802.1CB maintenance

"265" – FRER MatchRecoveryAlgorithm

IEEE 802.1 Maintenance TG
April, 2020

Talker fails (1):

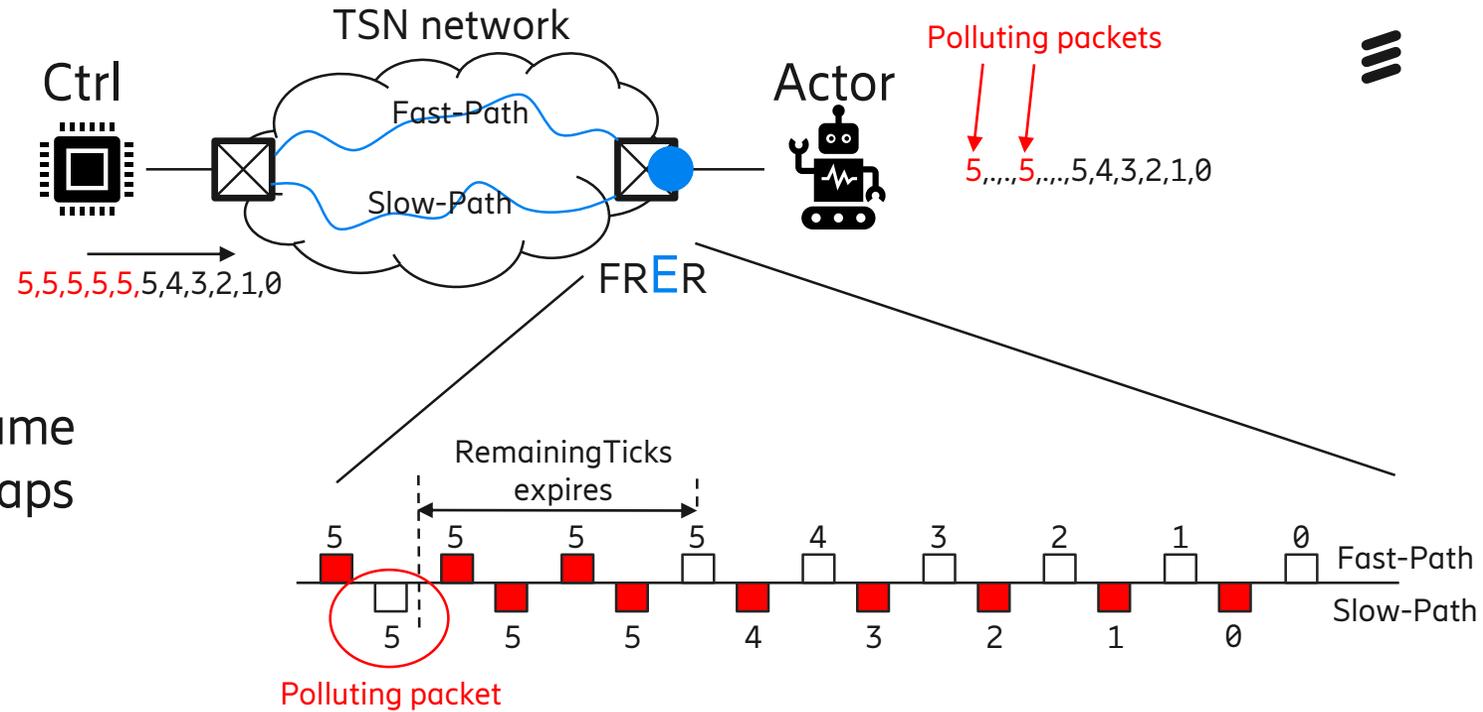
- repeatedly transmit packets with the same sequence_number subparameter (perhaps repeating exactly the same packet)
- here packet "5"

- works **only on multiple Member Streams** (frerSeqRcvyIndividualRecovery=FALSE)
 - Packets discarded by the MatchRecoveryAlgorithm will NOT cause the variable RemainingTicks (7.4.3.2.4) to be reset.
- result: first packet "5" accepted, than until RemainingTicks expires all packet "5" dropped. Next packet "5" accepted and again until RemainingTicks expires all packet "5" dropped ...

Talker fails (2):

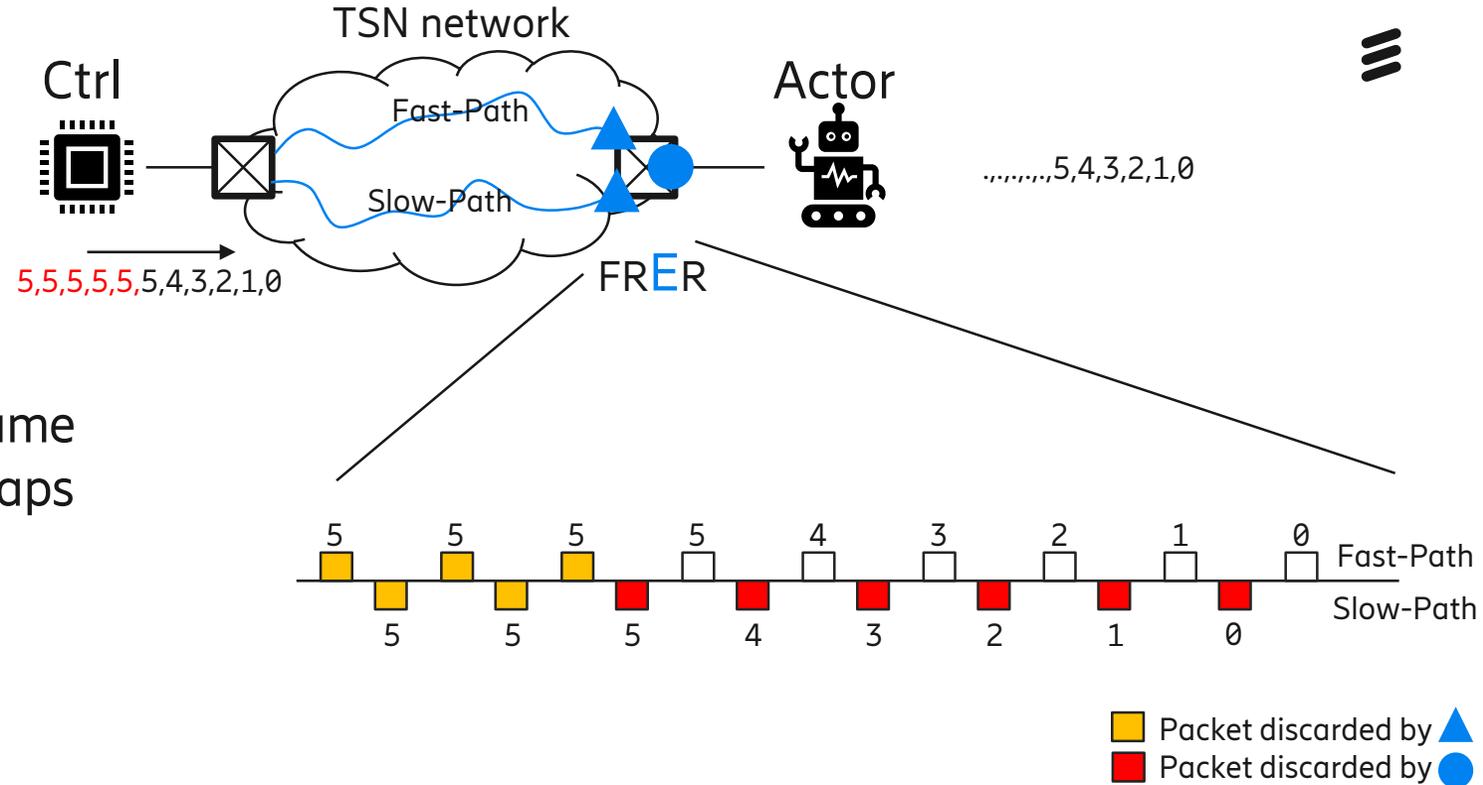
- repeatedly transmit packets with the same sequence_number subparameter (perhaps repeating exactly the same packet)
- here packet "5"

- ▲ — works on an **individual Stream** (frerSeqRcvyIndividualRecovery=TRUE)
 - Packets discarded by the MatchRecoveryAlgorithm will cause the variable RemainingTicks (7.4.3.2.4) to be reset.
 - result: first packet "5" accepted, than all packet "5" dropped
- — additionally it works **also on multiple Member Streams** (frerSeqRcvyIndividualRecovery=FALSE)
 - result: first packet "5" accepted, than RemainingTicks expires, but no more packet

Relay fails (1):

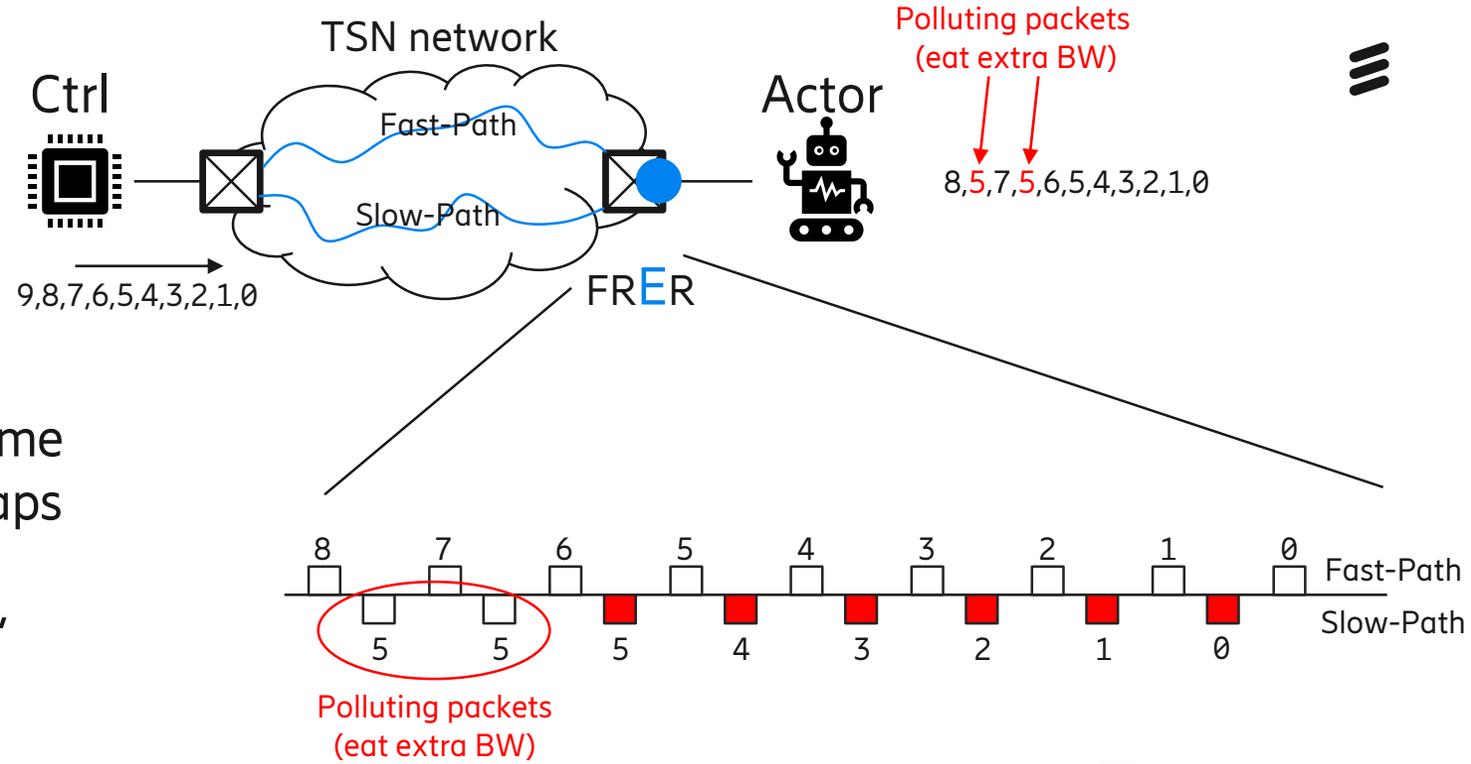
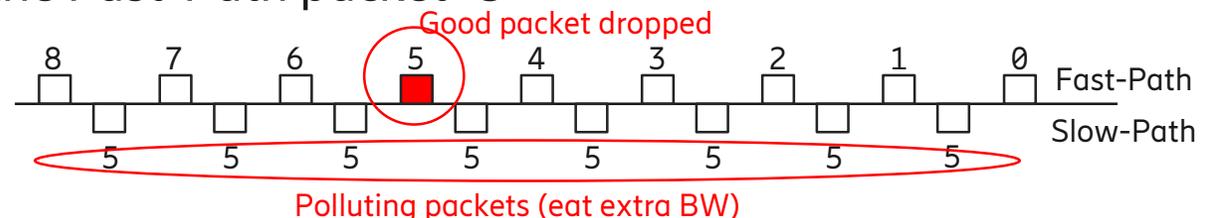
- repeatedly transmit packets with the same sequence_number subparameter (perhaps repeating exactly the same packet)
- here relay on Slow-Path fails, packet "5"

- works **only on multiple Member Streams** (frerSeqRcvyIndividualRecovery=FALSE)
 - Packets discarded by the MatchRecoveryAlgorithm will NOT cause the variable RemainingTicks (7.4.3.2.4) to be reset.
- result: first packet "5" accepted, after packet "6" all packet "5" accepted until wrap around. After wrap around the Slow-Path packet "5" kick off the Fast-Path packet "5"

Relay fails (2):

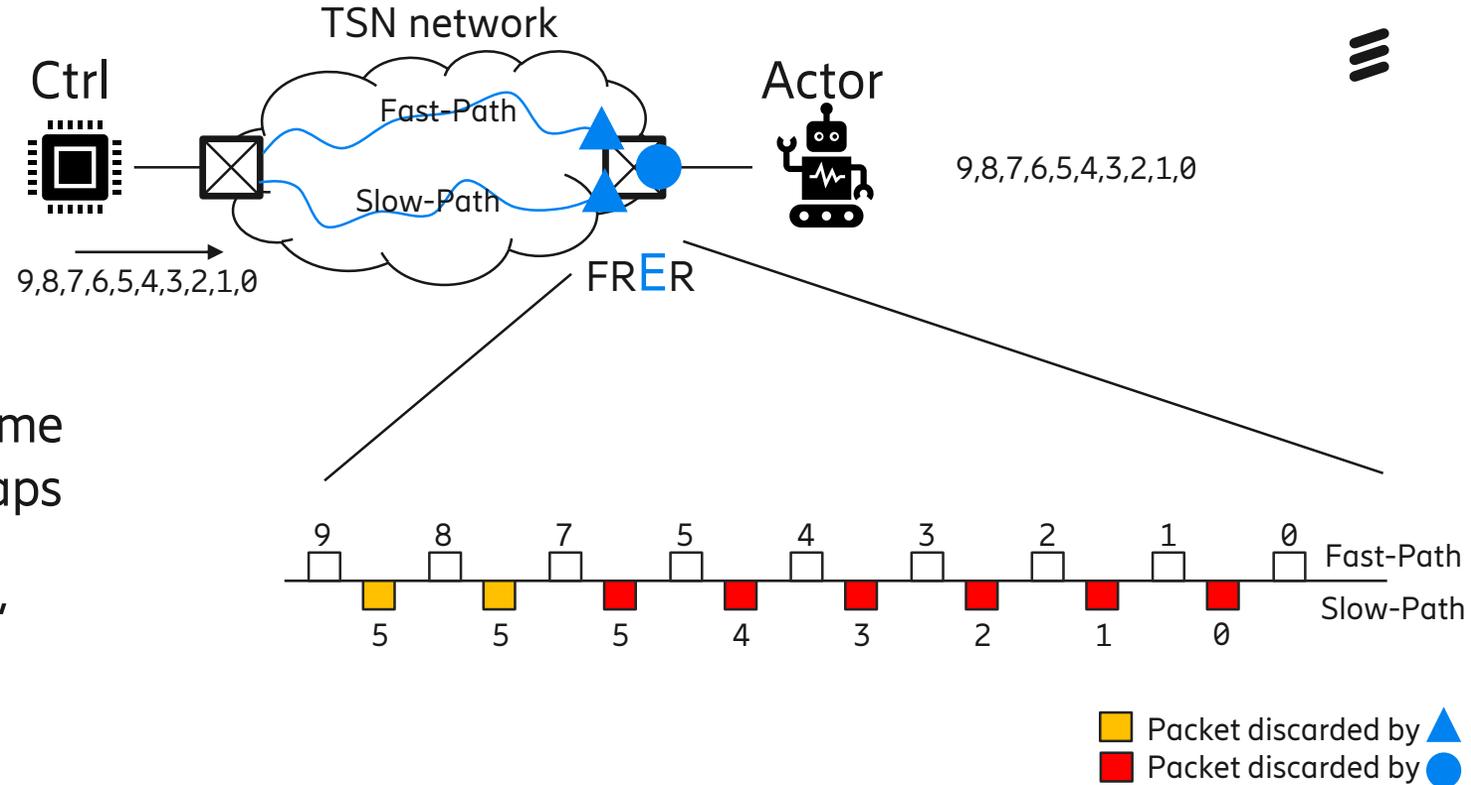
- repeatedly transmit packets with the same sequence_number subparameter (perhaps repeating exactly the same packet)
- here relay on Slow-Path fails, packet "5"

- ▲ works on an **individual Stream** (frerSeqRcvyIndividualRecovery=TRUE)
 - Packets discarded by the MatchRecoveryAlgorithm will cause the variable RemainingTicks (7.4.3.2.4) to be reset.
 - result: first packet "5" accepted, than all packet "5" dropped
- additionally it works **also on multiple Member Streams** (frerSeqRcvyIndividualRecovery=FALSE)
 - result: first packet "5" accepted, no issue at wrap around (Slow-Path packets already dropped by the Individual Recovery 😊)
